Architect's Supplemental Instructions

Architect's ASI No: 045

Project:
Webster University
Interdisciplinary Science
Building

Date Issued: 01/20/2017

3 SECTION THROUGH EAB ATTIC

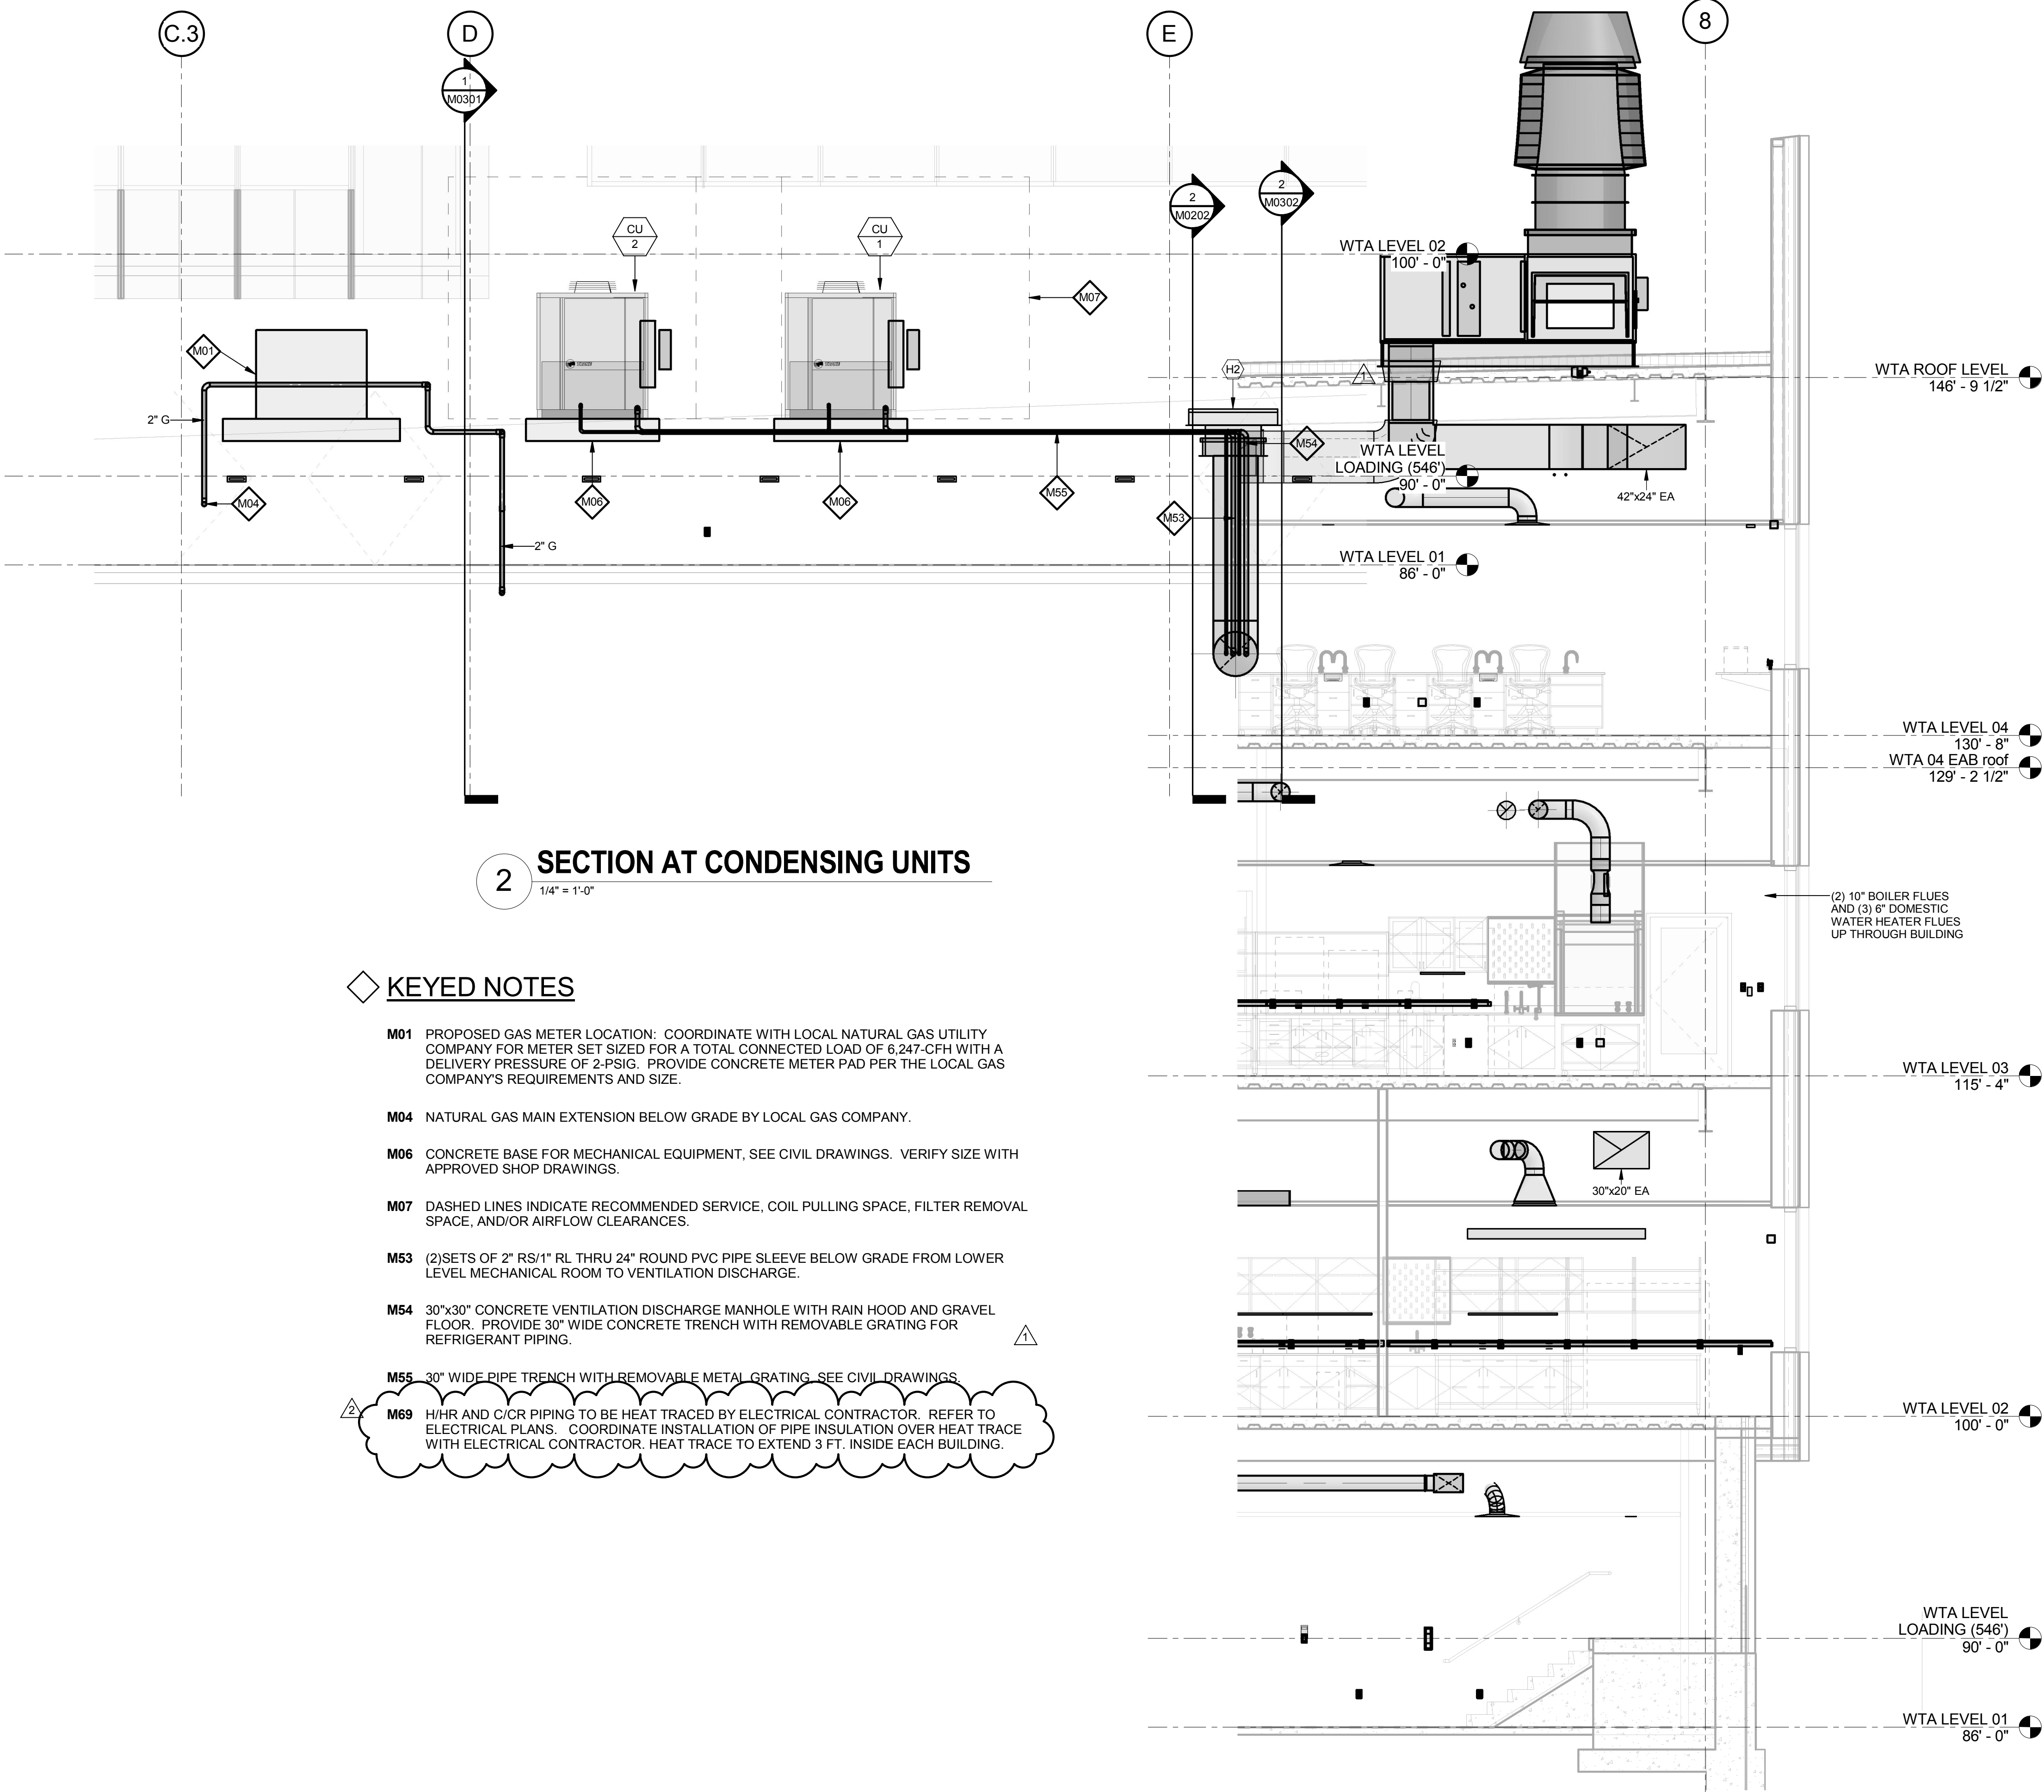
- Shifted H/HR, and C/CR risers north per RFI-408 Contractor proposed pipe routings between buildings.
- Added note M69 referring to electrical plans for heat tracing of H/HR, and C/CR piping.

- M55** 30" WIDE PIPE TRENCH WITH REMOVABLE METAL GRATING. SEE CIVIL DRAWINGS.
- M69** HHR AND C/C/R PIPING TO BE HEAT TRACED BY ELECTRICAL CONTRACTOR. REFER TO ELECTRICAL PLANS. COORDINATE INSTALLATION OF PIPE INSULATION OVER HEAT TRACE WITH ELECTRICAL CONTRACTOR. HEAT TRACE TO EXTEND 3 FT. INSIDE EACH BUILDING.

SHEET E0103.A LEVEL 03 AREA A FLOOR PLAN – ELECTRICAL & AUXILIARY

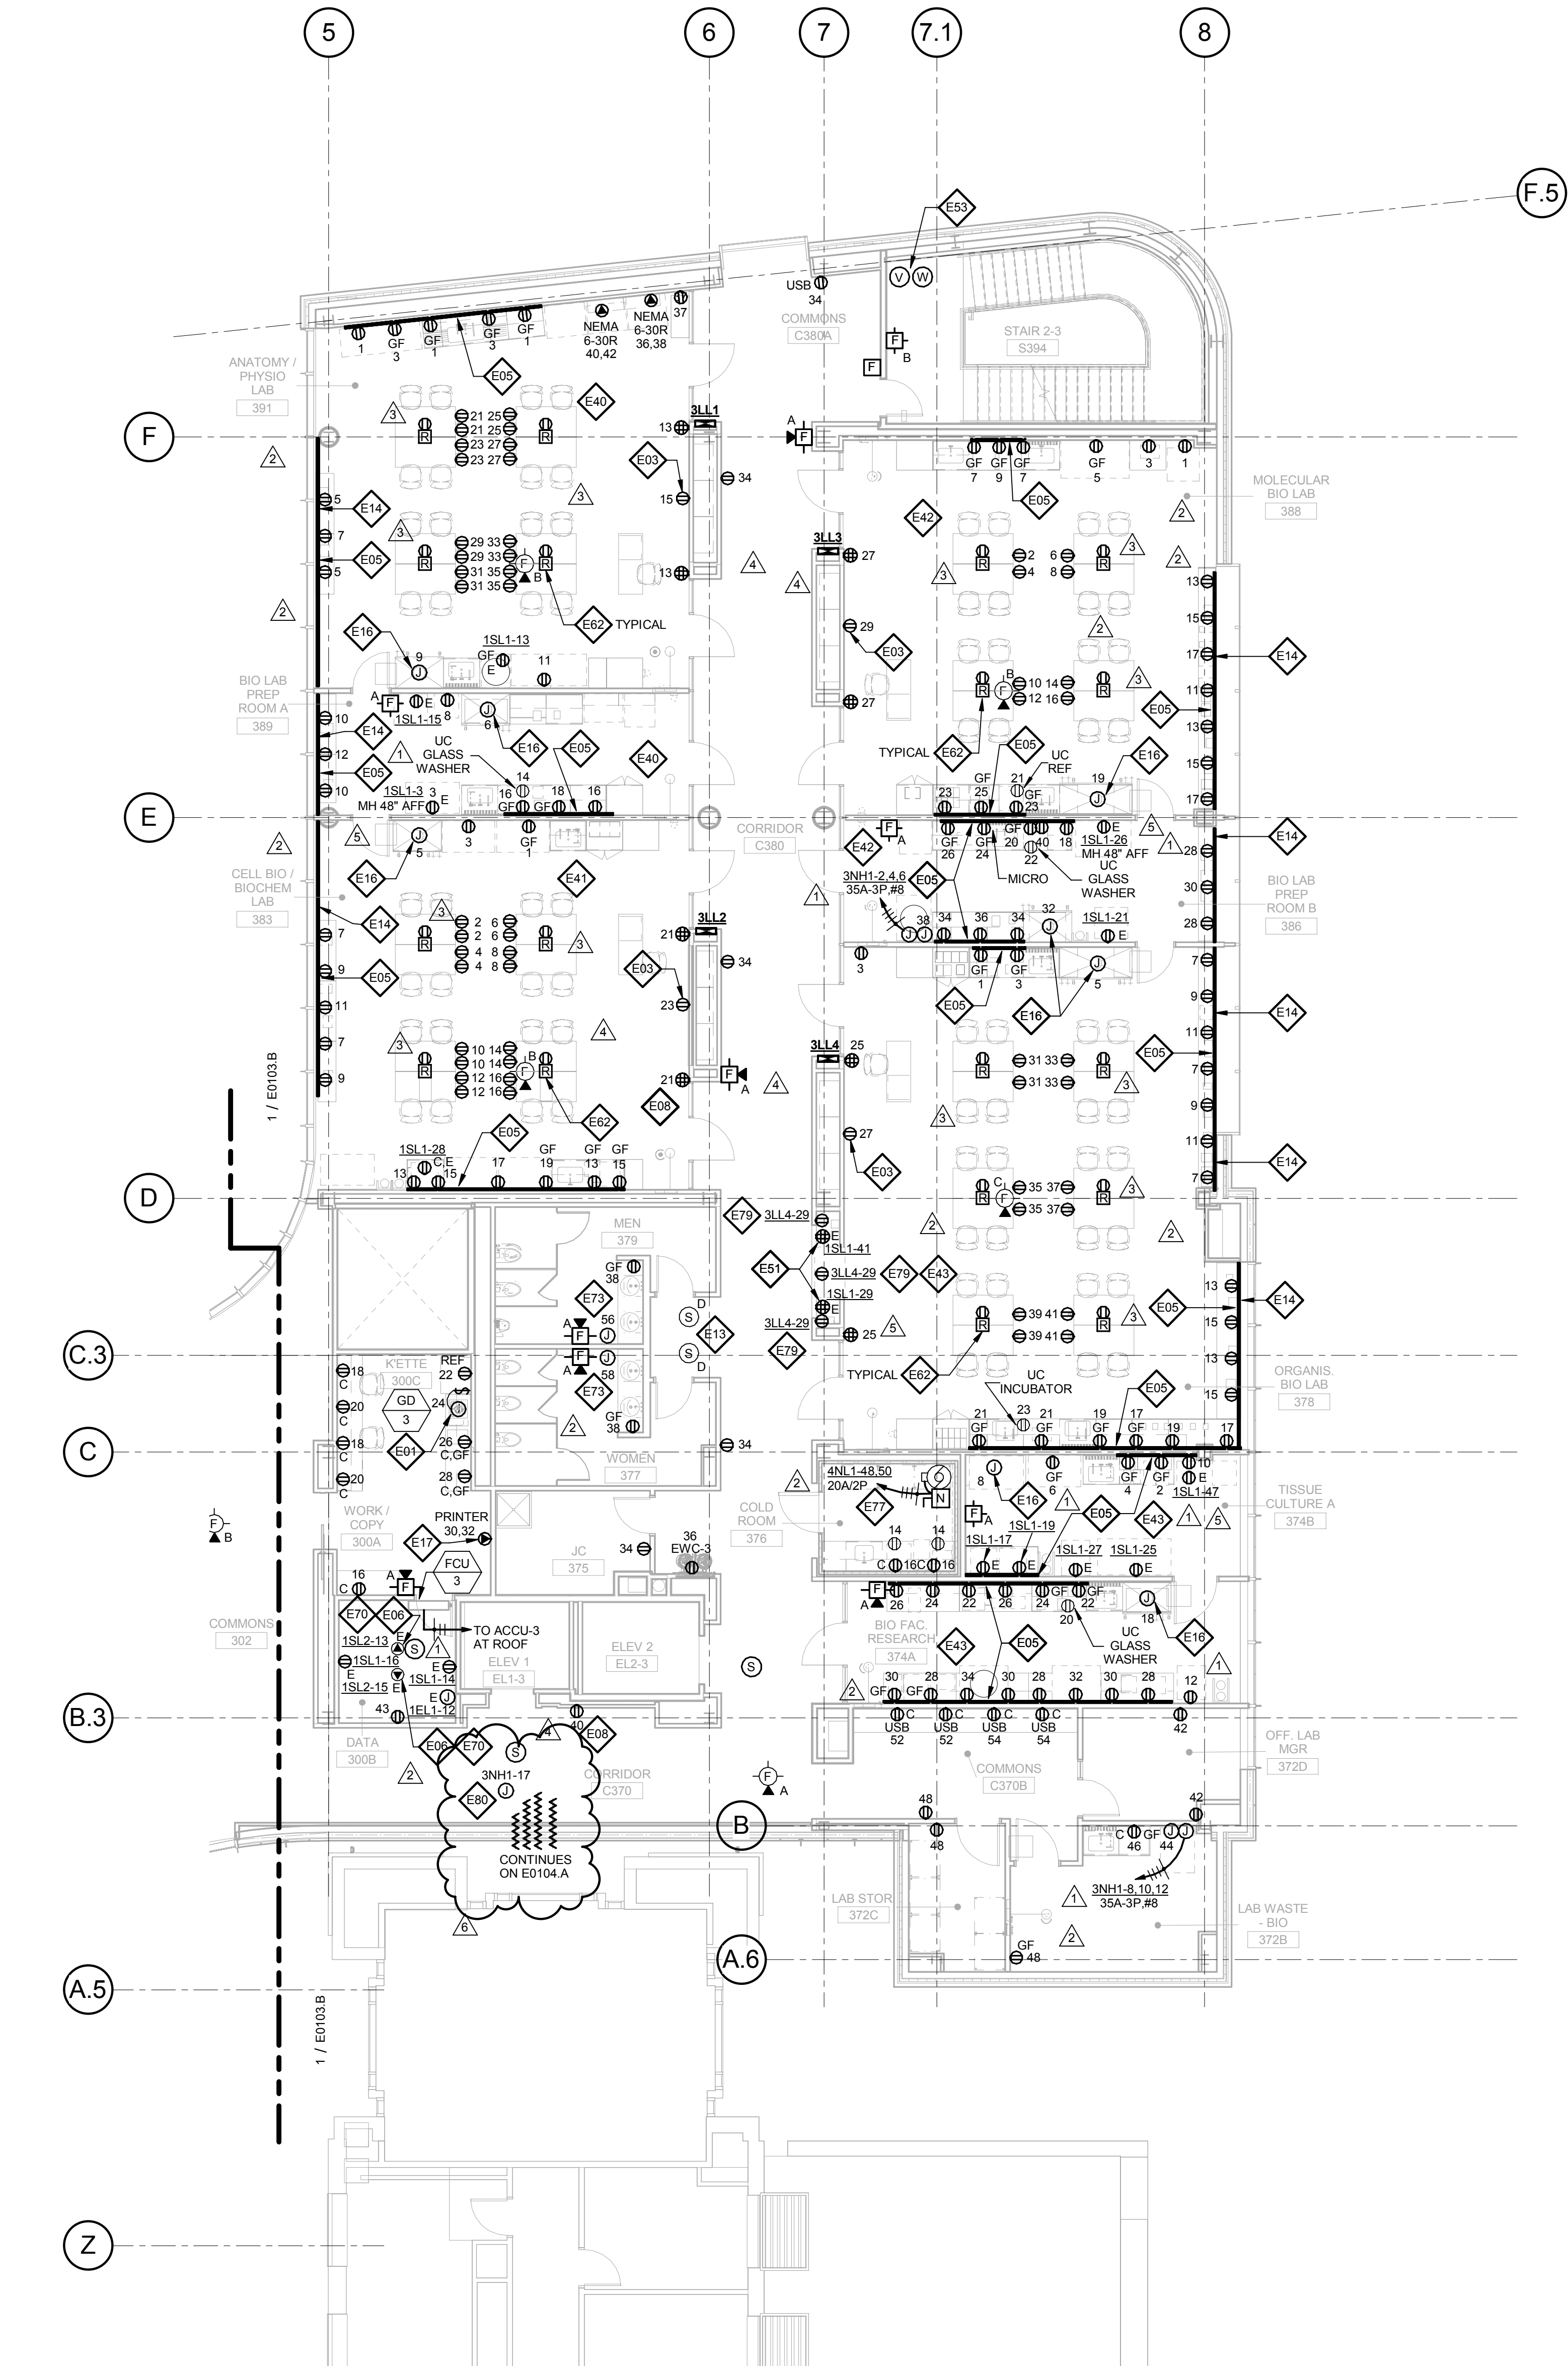
- In Corridor C370, provide pipe freeze protection for hot and cold water piping.
- Add Keyed Note E80 for pipe freeze protection.

- E79** PROVIDE 20A GFCI DUPLEX RECEPTACLE CEILING MOUNTED FOR POWER TO AQUARIUM LIGHTS. COORDINATE EXACT LOCATION WITH ARCHITECTURAL PLANS AND ELEVATIONS.
- E80** PROVIDE PIPE FREEZE PROTECTION OF COLD AND HOT WATER SUPPLY AND RETURN PIPING. REFER TO SHEET M0103.A, M0104.A, AND SECTION THROUGH EAB ATTIC ON SHEET M0303 FOR LENGTH OF PIPES, AND SPECIFICATION SECTION 268500 FOR ADDITIONAL INFORMATION.

1 LEVEL 04 - AREA A - FLOOR PLAN - POWER AND AUXILLARY

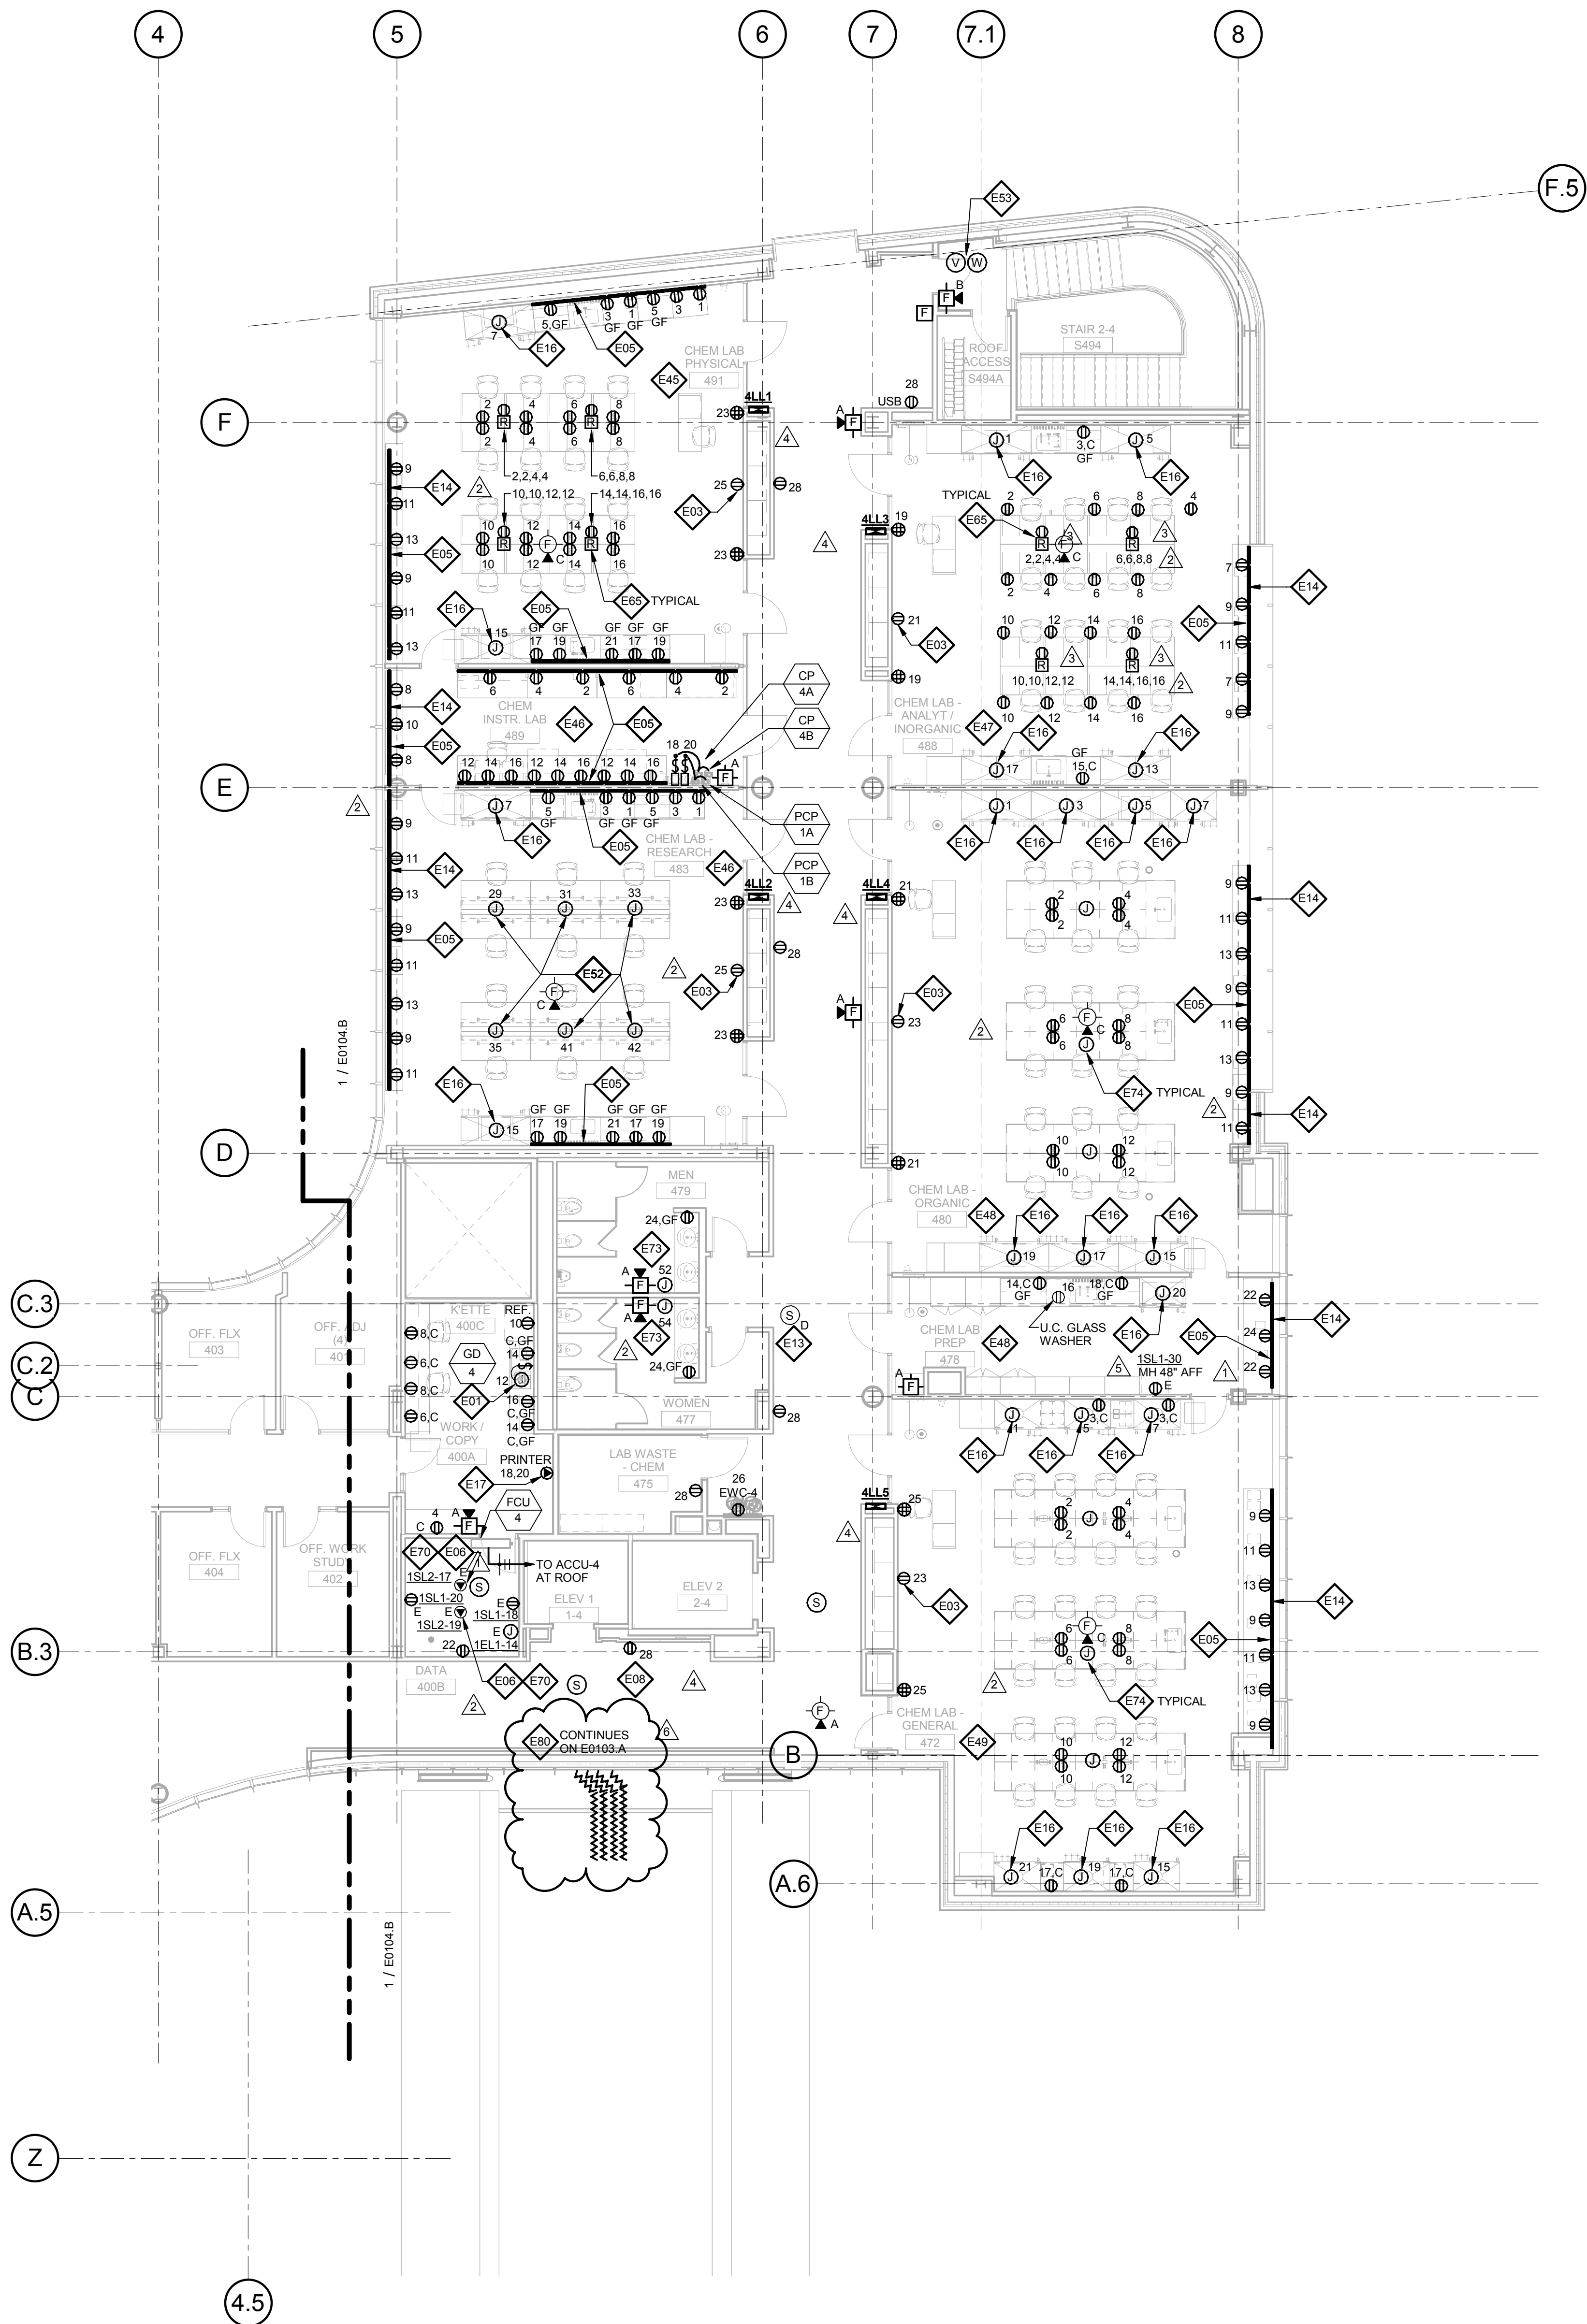
- At EAB/ISB connection, provide pipe freeze protection for hot and cold water piping.
- Add Keyed Note E80 for pipe freeze protection.

E80 PROVIDE PIPE FREEZE PROTECTION OF COLD AND HOT WATER SUPPLY AND RETURN PIPING. REFER TO SHEET M0103.A, M0104.A, AND SECTION THROUGH EAB ATTIC ON SHEET M0303 FOR LENGTH OF PIPES, AND SPECIFICATION SECTION 268500 FOR ADDITIONAL INFORMATION.
